Burlington Development Review Board

Development Review Board

Tuesday, September 1, 2026, 5:00 PM

TO: Development Review Board
FROM: Scott Gustin
DATE: September 1, 2026
RE: ZP-24-50; 75 Briggs Street

SOUTH & EAST
BUILDING
ELEVATIONS

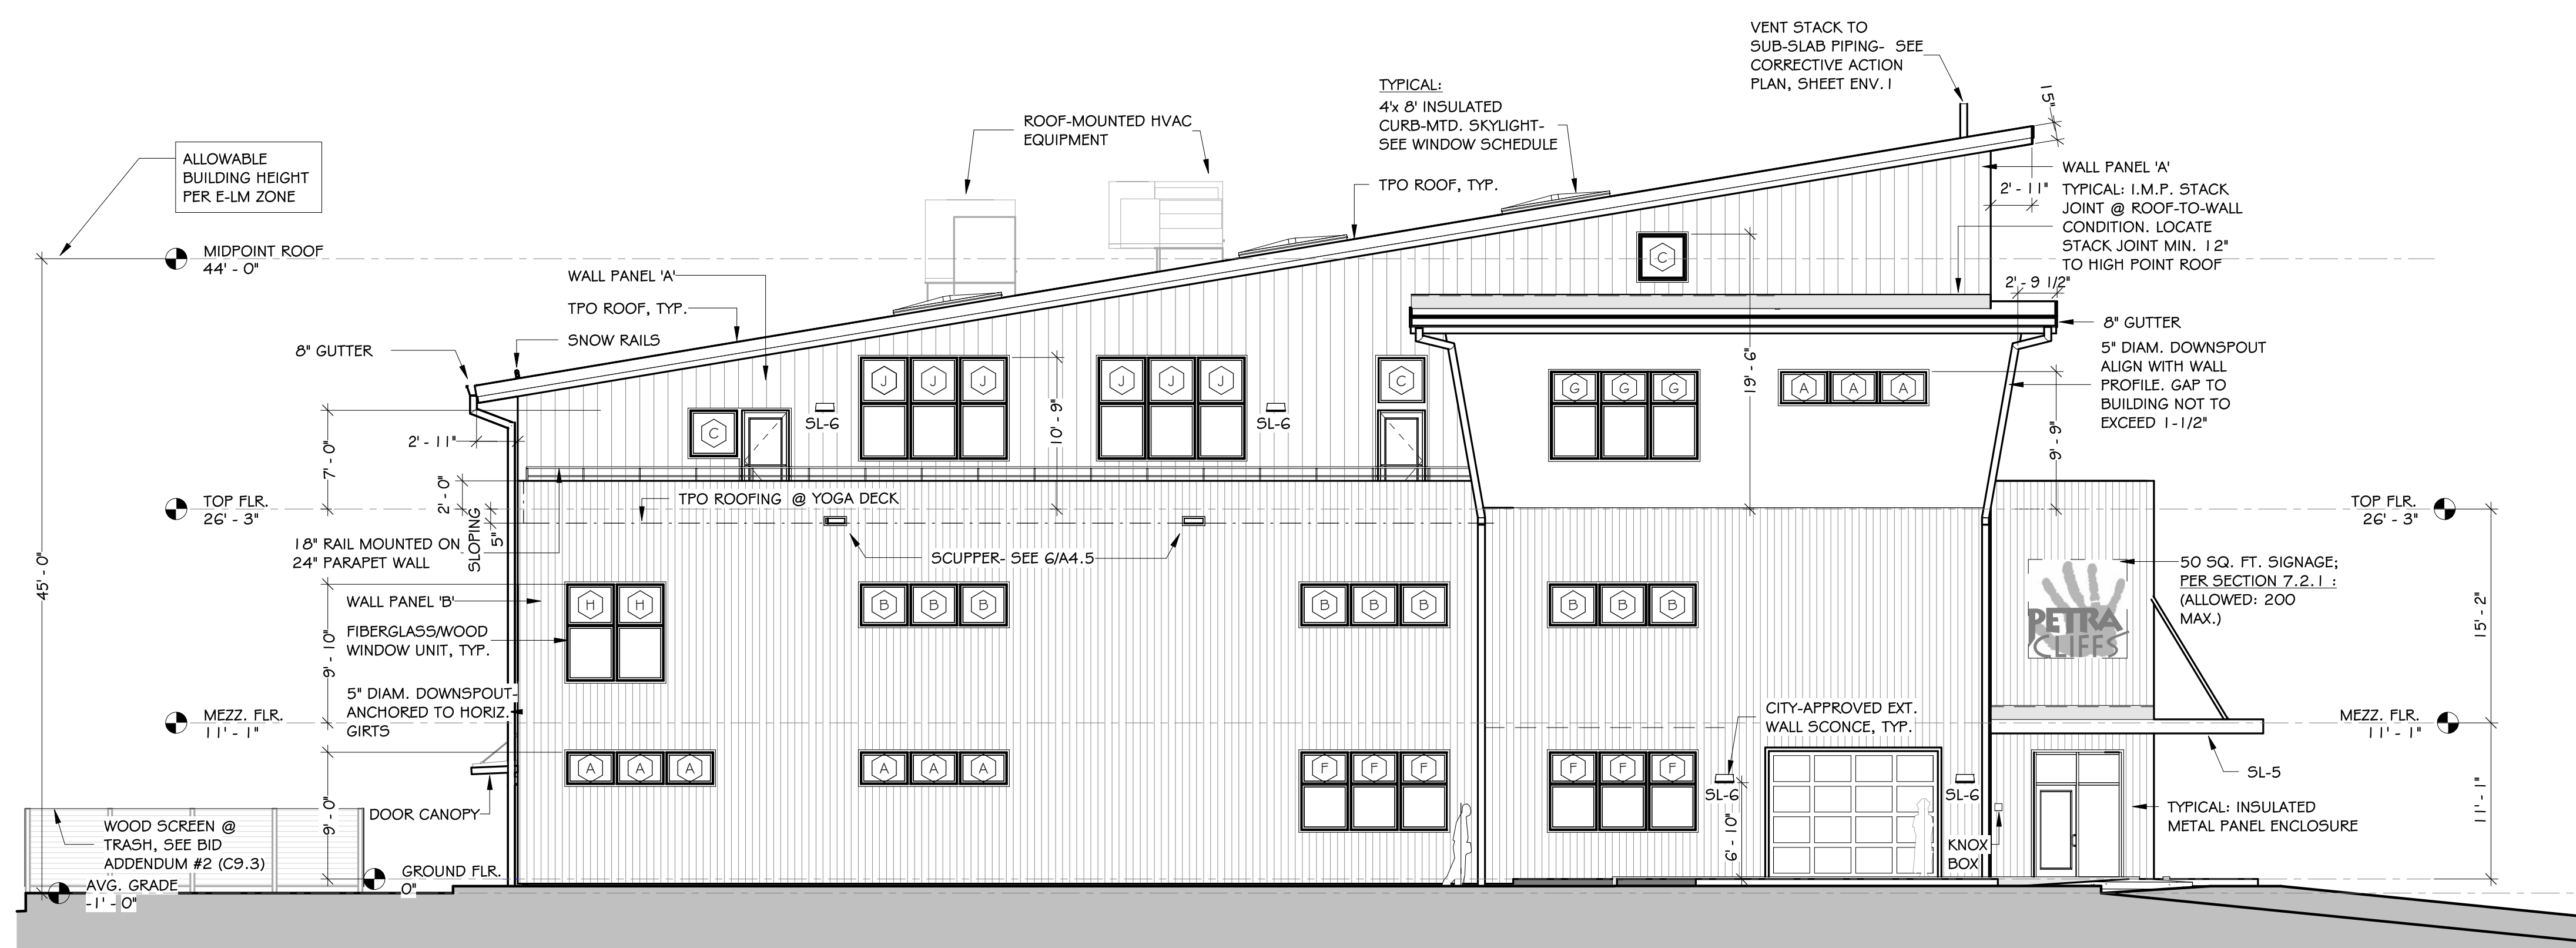
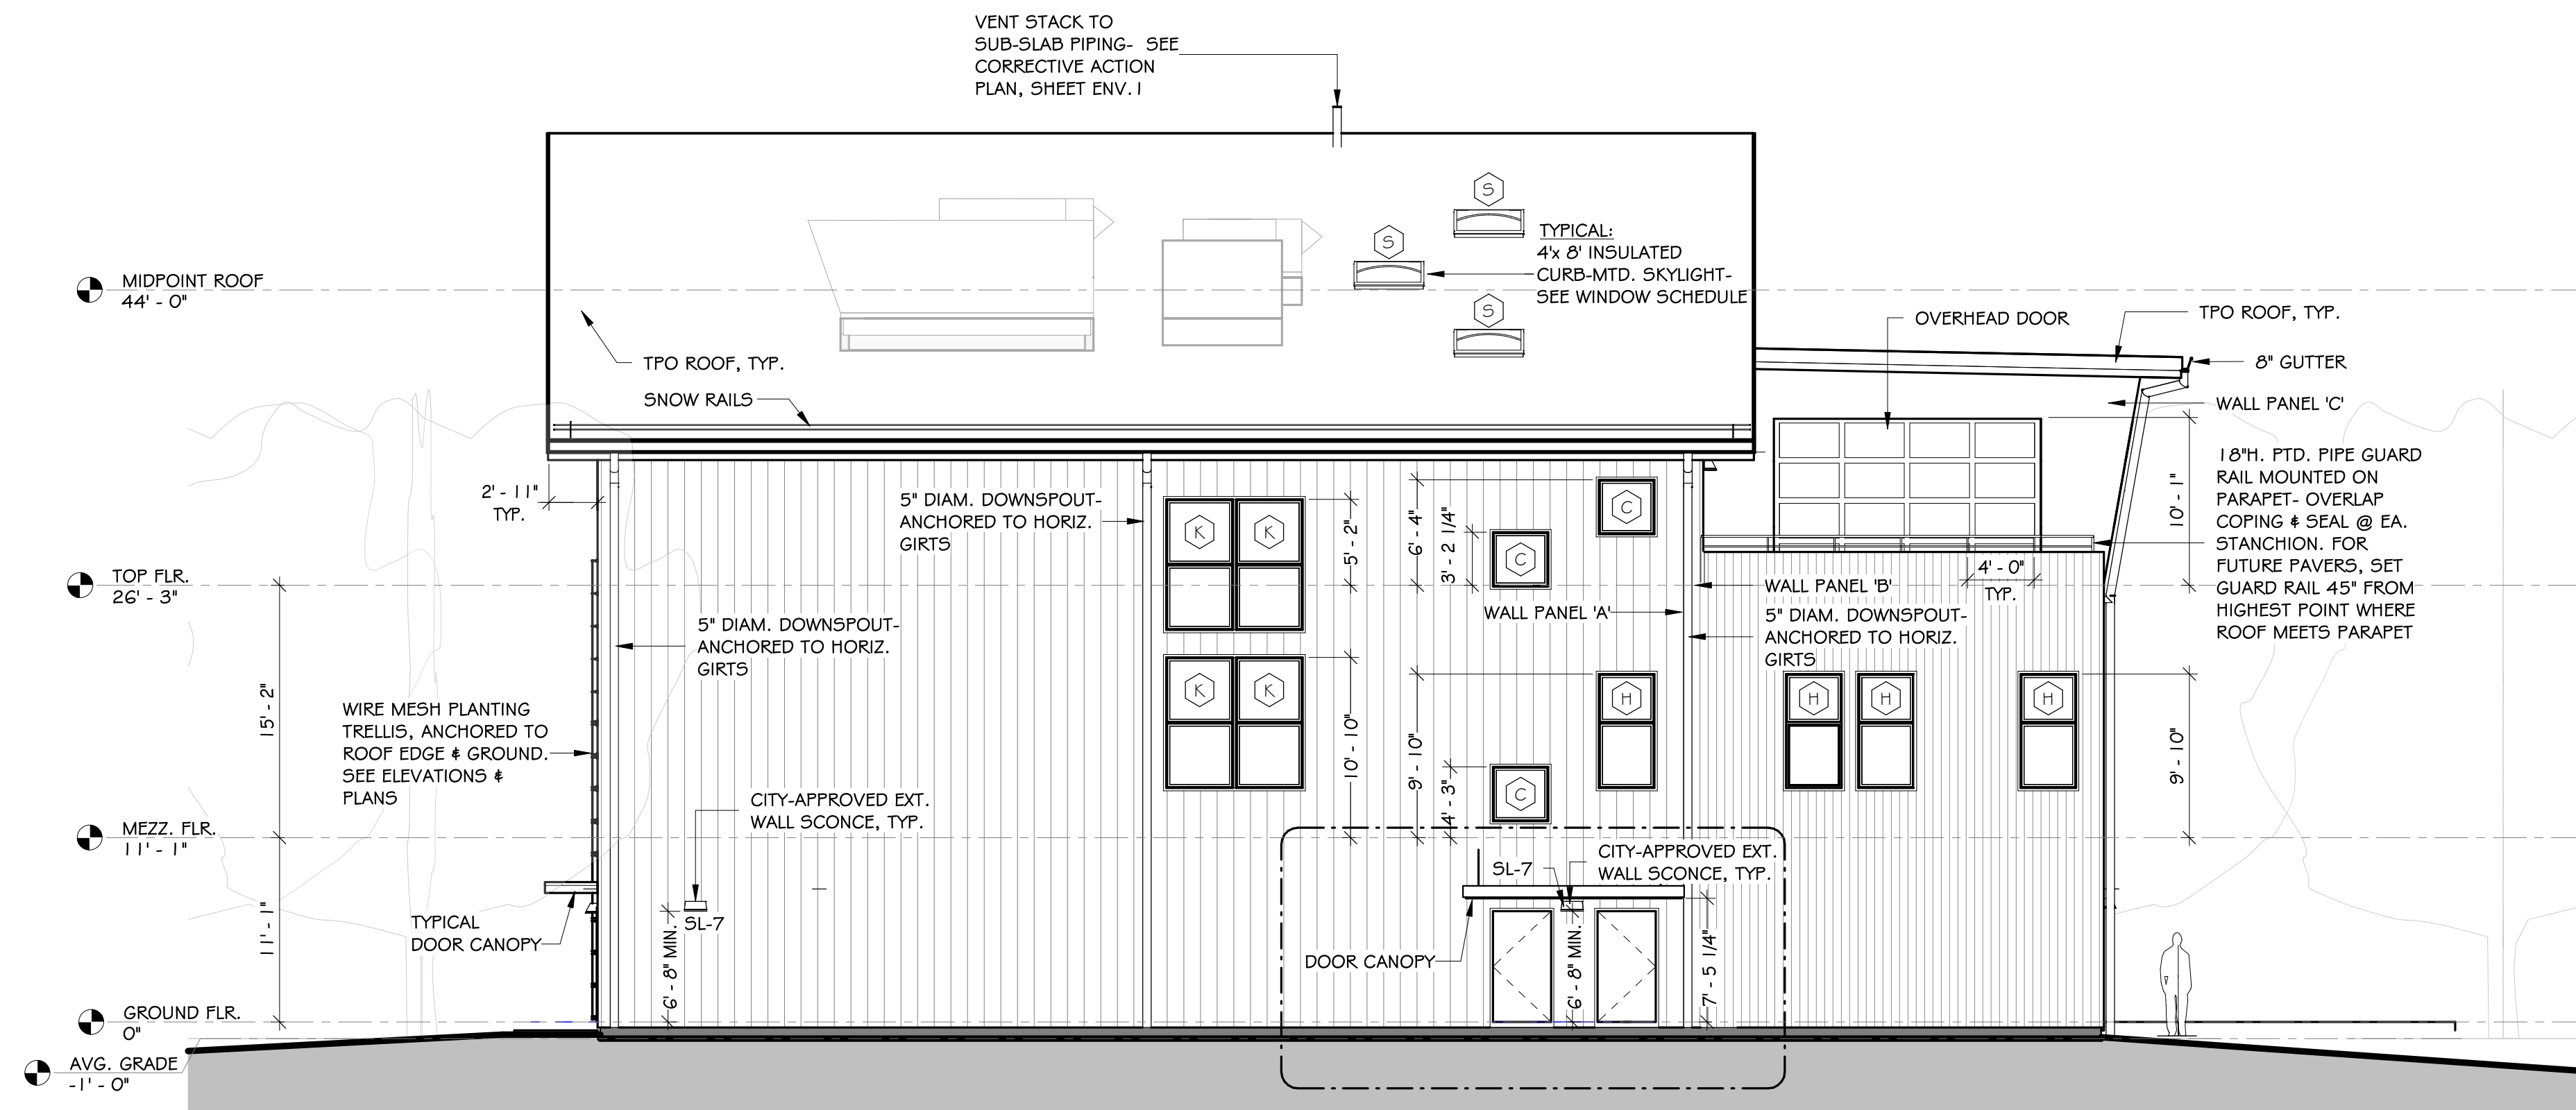
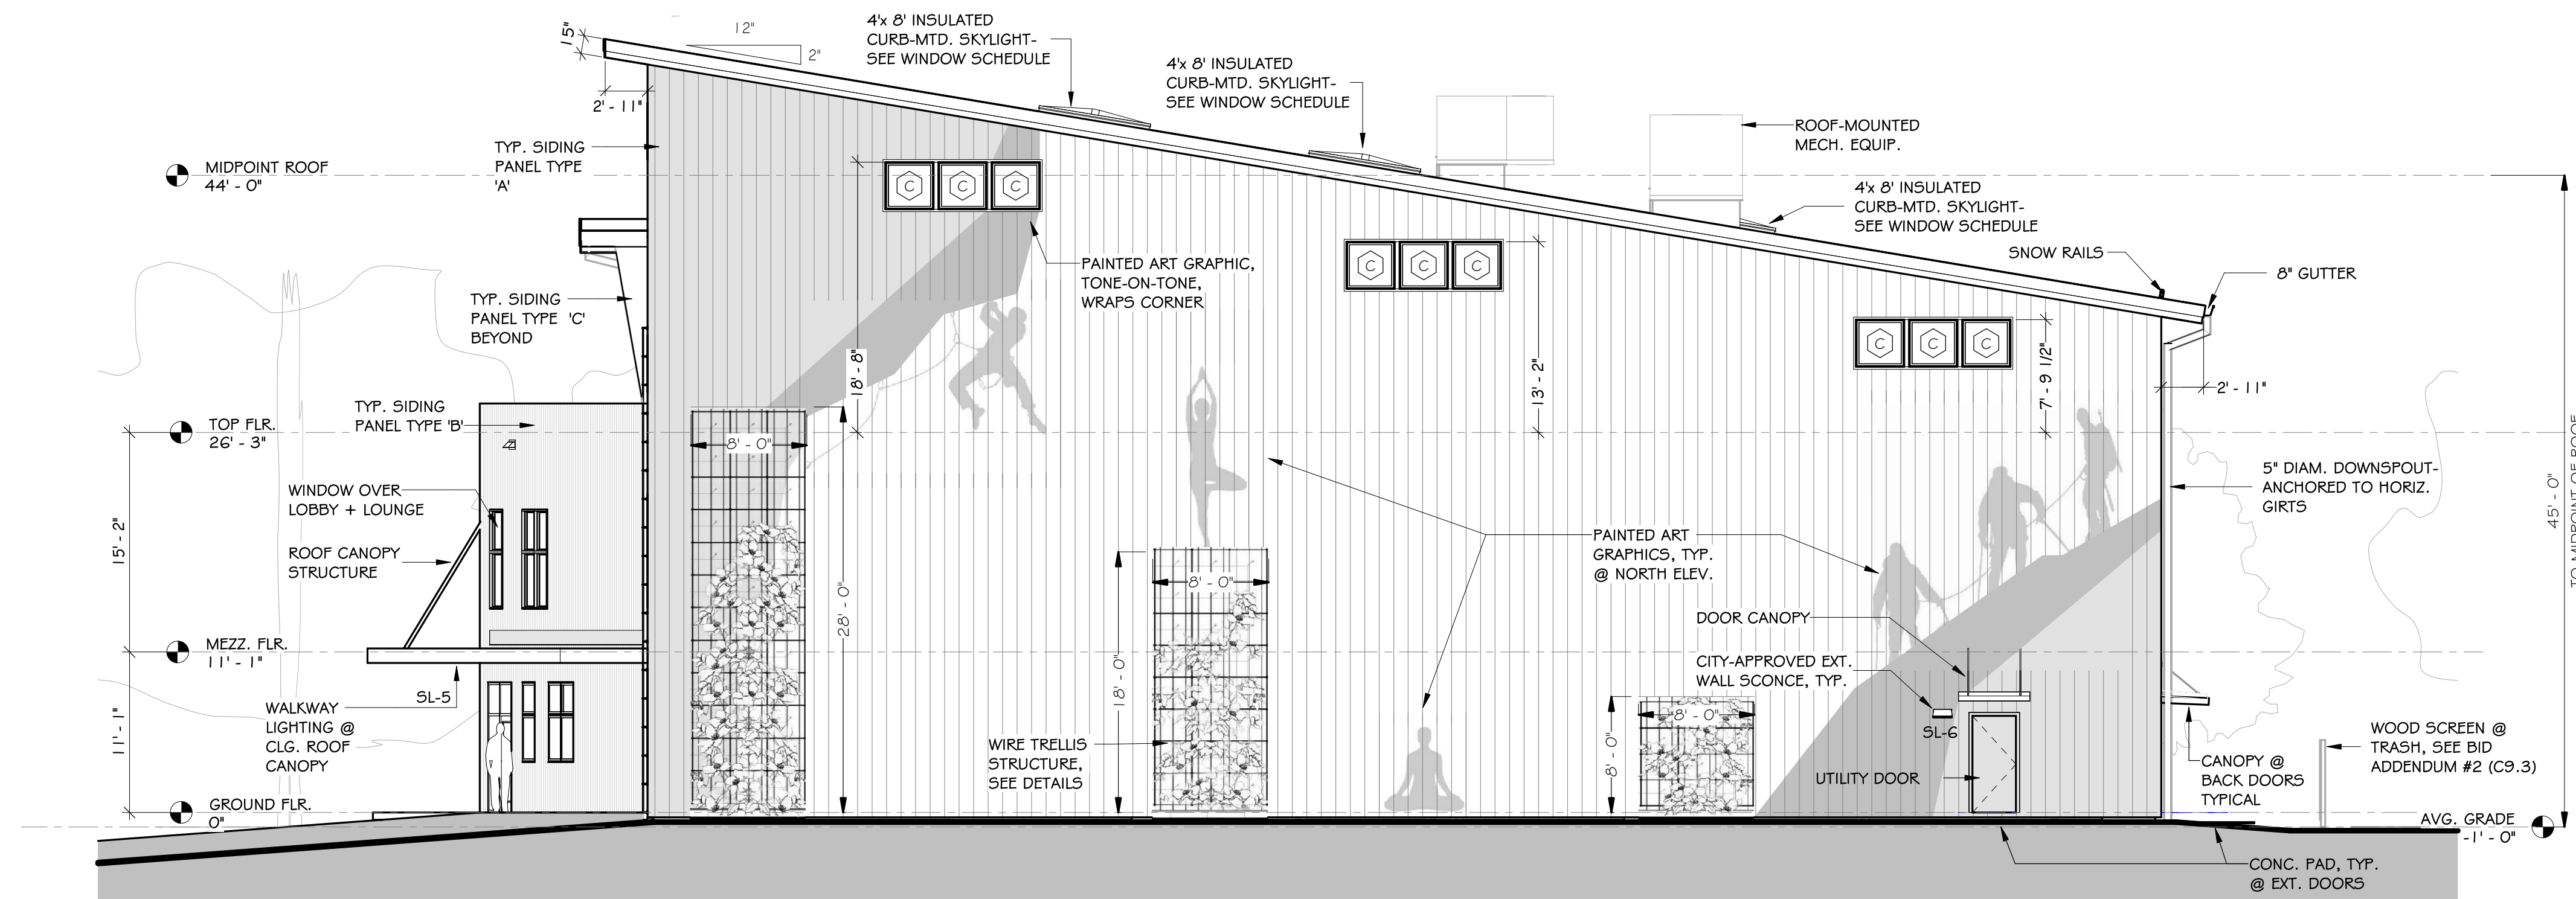
The primary building entrance is sheltered and oriented towards Briggs Street. It is somewhat revised in the new project plans, most notably containing more mass along Briggs Street and including exterior signage. The main entrance is also accessible from the parking area to the south. The primary entrance clearly reads as such. Building fenestration has been modified in the new project plans but remains consistent with the angular, boxy appearance of the building. The function of the building's interior as a climbing center limits the placement and extent of fenestration. **(Affirmative finding)**

Exterior signs are depicted on the elevation plans. Sign location and area appear to be acceptable. **(Affirmative finding)**

Project plans depict rooftop mechanical equipment. The equipment is set midway down the back of the sloping shed roof. In this location, the roof itself provides screening of the equipment as viewed from the public street. **(Affirmative finding)**
